Re: Docket No. CSC 461A - Greenwich Substation and Line Project, Development and Management Plan, Vol. 1, Part 1- Cos Cob Substation Modifications

Response to CSC-01 Interrogatories dated 03/19/2018
CSC-001, 002, 003, 004, 005, 010

**Data Request CSC-01
Dated: 03/19/2018**

BY: JA (PEI)	DRW: APP	APP: APP	APP: APP
DATE: DATE	DATE: DATE	DATE: DATE	DATE: DATE
H-SCALE: 1"=20'	SIZE: D	FIELD BOOK & PAGES	
V-SCALE: V.S.	R.E. DWG		
R.E. PROJ. NUMBER	DWG NO. 15706-10034 PG 2

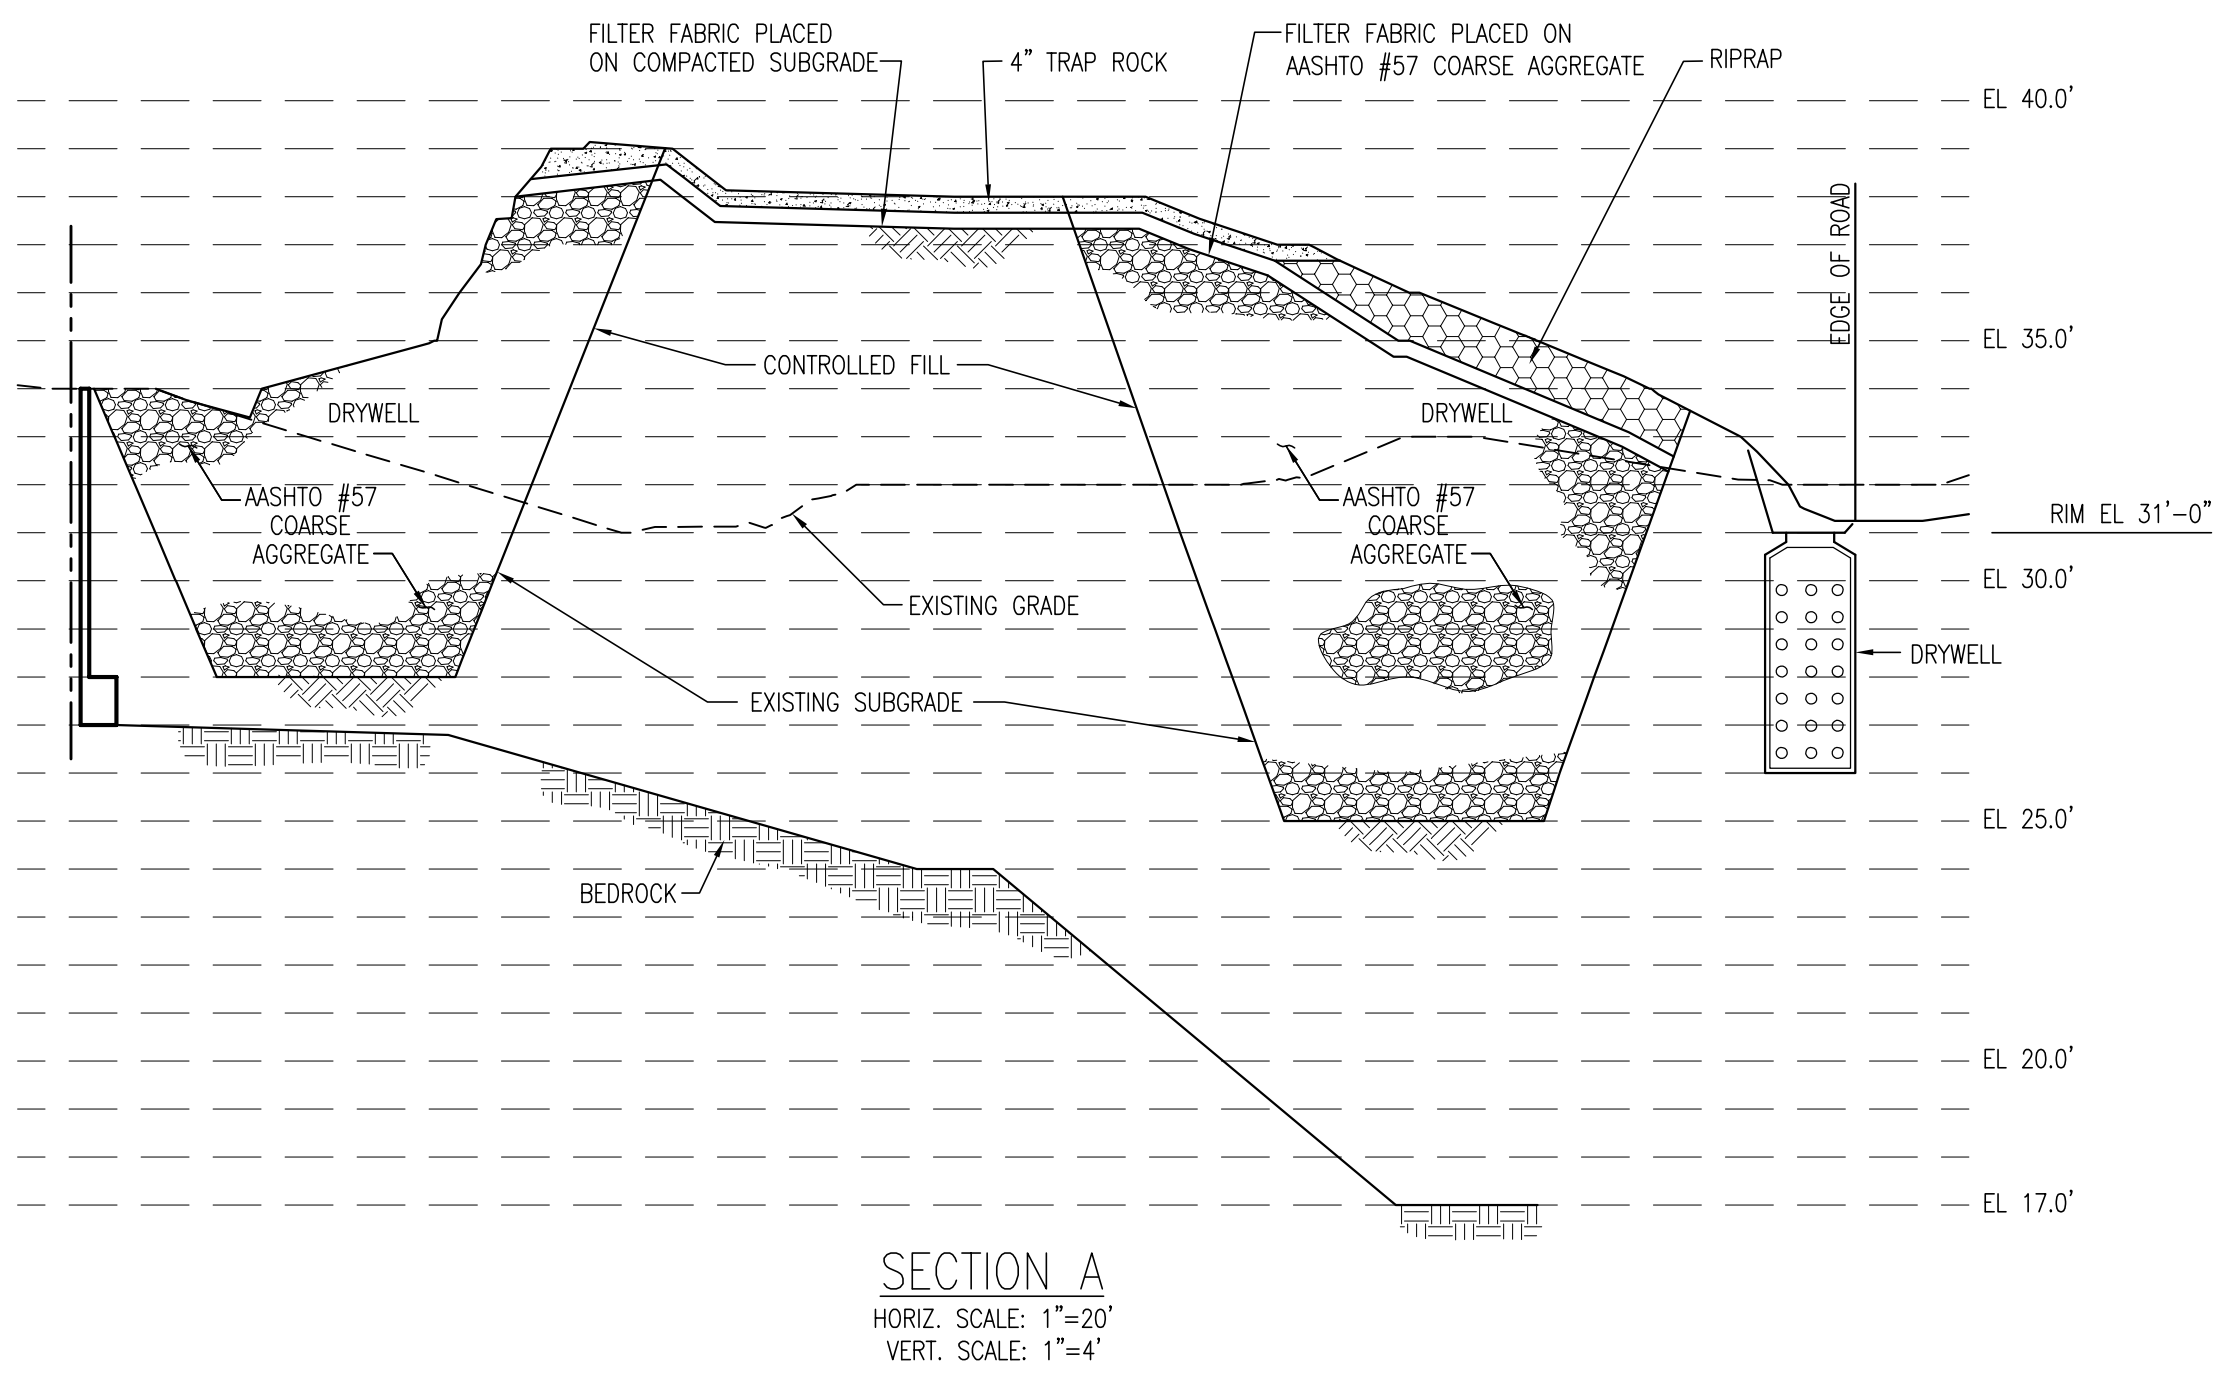
Referring to Site Plan Sheet 10034, two excavation areas are depicted on the east end and south end of the project site. A reference to "Note 9" is made but "Note 9" is not provided on the sheet. Please provide the following:

- a. what is the purpose of each area?
- b. provide a cross-section detail of each area that depicts material composition and depth.
- c. what is the depth to bedrock in each area? If depth to bedrock is unknown, what measures would be undertaken to ensure the proposed subsurface features can be constructed as proposed?
- d. what construction/ drainage standard was used to determine appropriate size of each area?
- e. are these are permanent or temporary features? If permanent, what cover material will be used in each area?

- a. The purpose of these areas is to function as dry wells and allow storm water to infiltrate into the soils below.
- b. Please see attached cross-section Drawing No.15706-10034PG2.
- c. Based on the results of site borings, bedrock varies in these two areas. Please see Section A of the attached cross-section drawing.
- d. The Project utilized the Town of Greenwich Drainage Manual, Revised February 2014, and the Standard Handbook for Civil Engineers, as references to determine runoff and the size of the dry wells.
- e. These areas are proposed to be permanent features. Cover material will be stone, as shown in the cross-section referenced in the response to part b. above.

EVERSOURCE ENERGY				
TITLE COS COB 11R SITE DEVELOPMENT PLAN CIVIL PLAN & DETAILS GREENWICH, CT				
BY PS (PEI)	DATE	APP APP	DATE	APP
H-SCALE 1"=20'	SIZE D	FIELD BOOK & PAGES		
V-SCALE	V.S.	R.E. DWG		
R.E. PROJ. NUMBER				DWG NO. 15706-10033

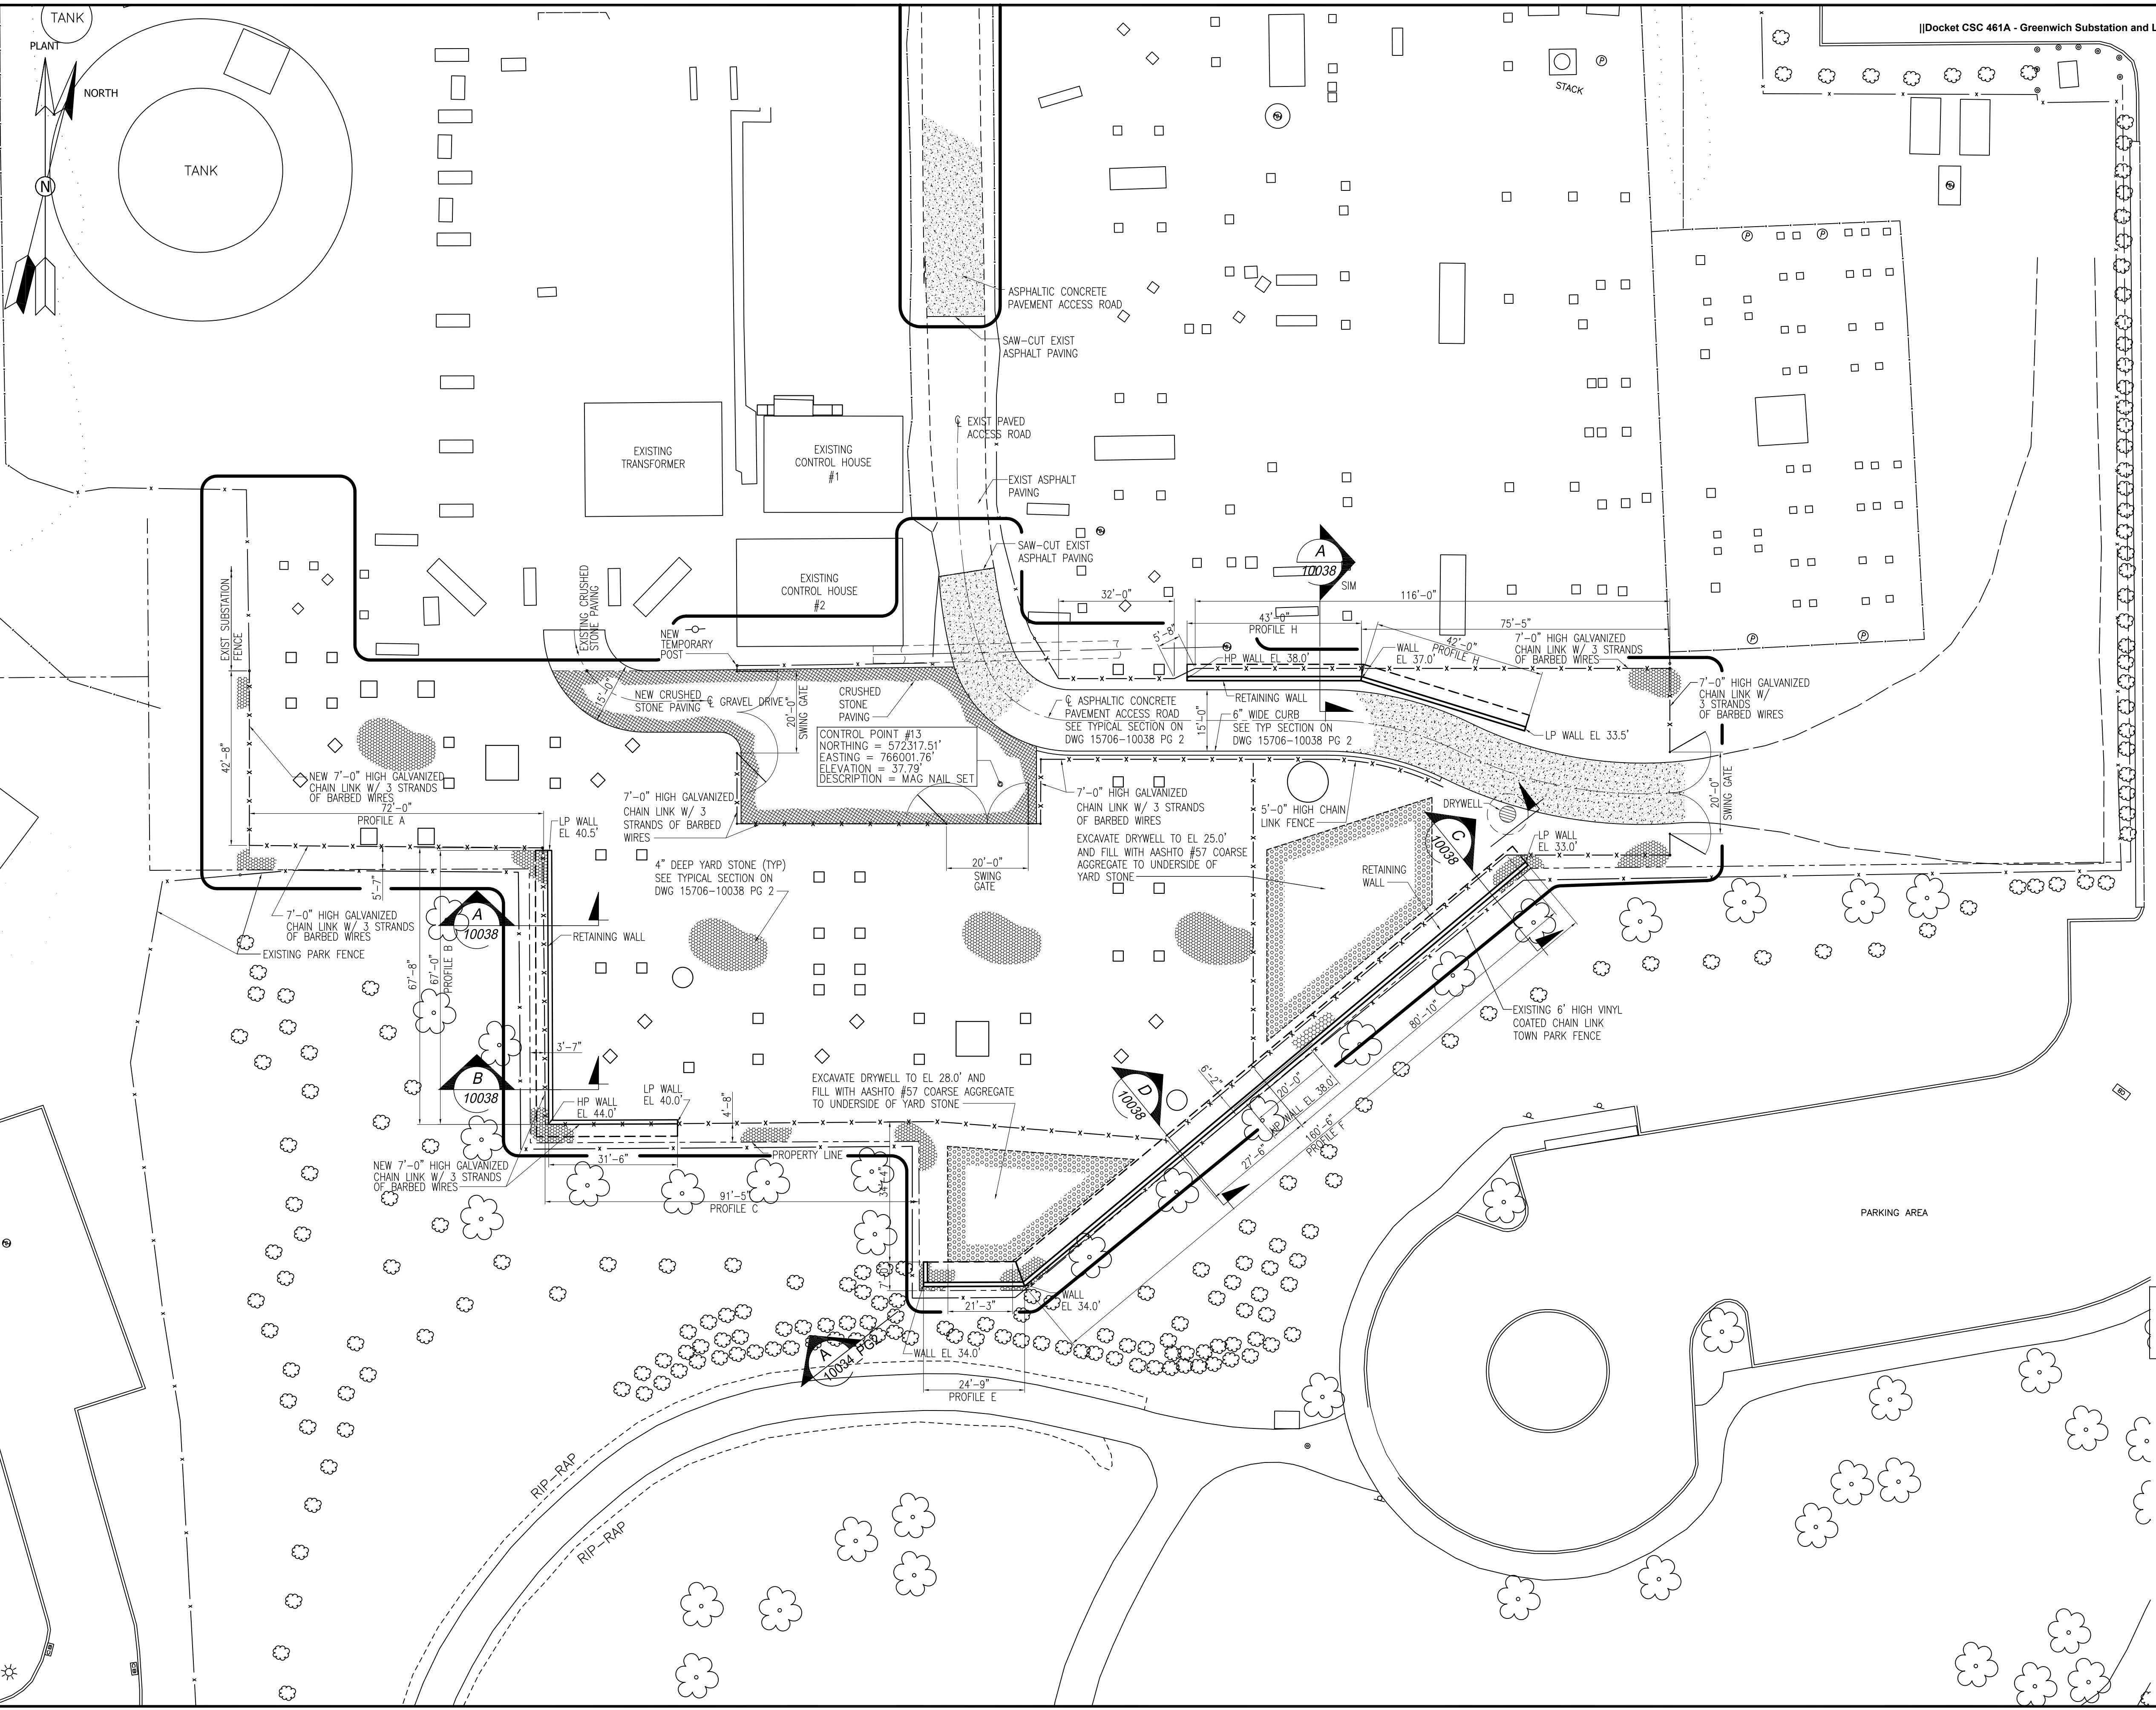
Referring to Site Plan Sheet 10033, two access points are shown to the substation expansion area, a north entrance and an east entrance. Are one or both entrances being used during construction?

The north entrance is the only entrance to the site. The east gate/access depicted on the D&M Plan is an access utilized by Metro-North Railroad. There is no access to a public right-of-way from this gate and the Project personnel will not be utilizing this access for the Project work.

Also, please see the minor modifications to the permanent fence location depicted on the revised Drawing No. 15706-10033 (attachment to response CSC-002) and the addition of a curb along the driveway. See also attached revised Drawing 15706-10038 PG1 regarding fencing and retaining wall plans and sections.

EVERSOURCE ENERGY	
TITLE COS COB 11R GRADING AND DRAINAGE PLAN - FINISHED GRADES CIVIL PLAN & DETAILS GREENWICH, CT	
BY AMW (PE)	APP APP
DATE	DATE
H-SCALE 1"=20'	FIELD BOOK & PAGES
V-SCALE	R.E. DWG
R.E. PROJ. NUMBER	DWG NO. 15706-10034 PG 1

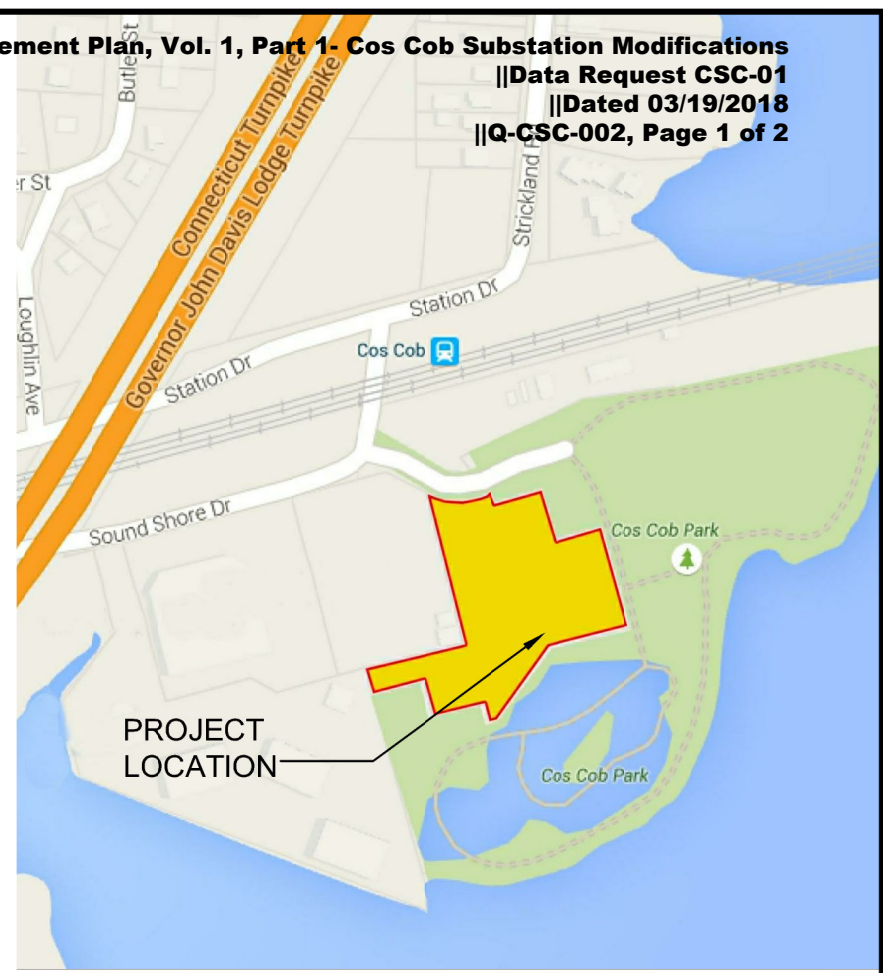
Referring to Site Plan Sheet 10034, provide a cross section detail of the drainage pipe/ catch basin system on the east side of the site, including proposed ground elevation and depth into any subsurface drainage material. What is the size of the proposed catch basin? What criterion was used to determine that one catch basin is sufficient to capture post-construction stormwater flows?

Please see the response to CSC-001.b. for the requested cross section. The catch basin is actually a concrete dry well that is 10 feet in diameter and 5 feet deep, as depicted on attached Drawing 15706-10034 PG1 and Drawing 15706-10034 PG2 (attached as a response to CSC-001 b). The concrete dry well will be utilized to collect stormwater from only the paved roadway and allow it to infiltrate into the soils below. The remaining area of the substation will drain via sheet flow to the two stone-filled dry wells, the locations of which are shown on attached Drawing 15706-10033 and Drawing 15706-10034 PG2. The Project utilized criteria from the Town of Greenwich Drainage Manual, Revised February 2014, and the Standard Handbook for Civil Engineers.
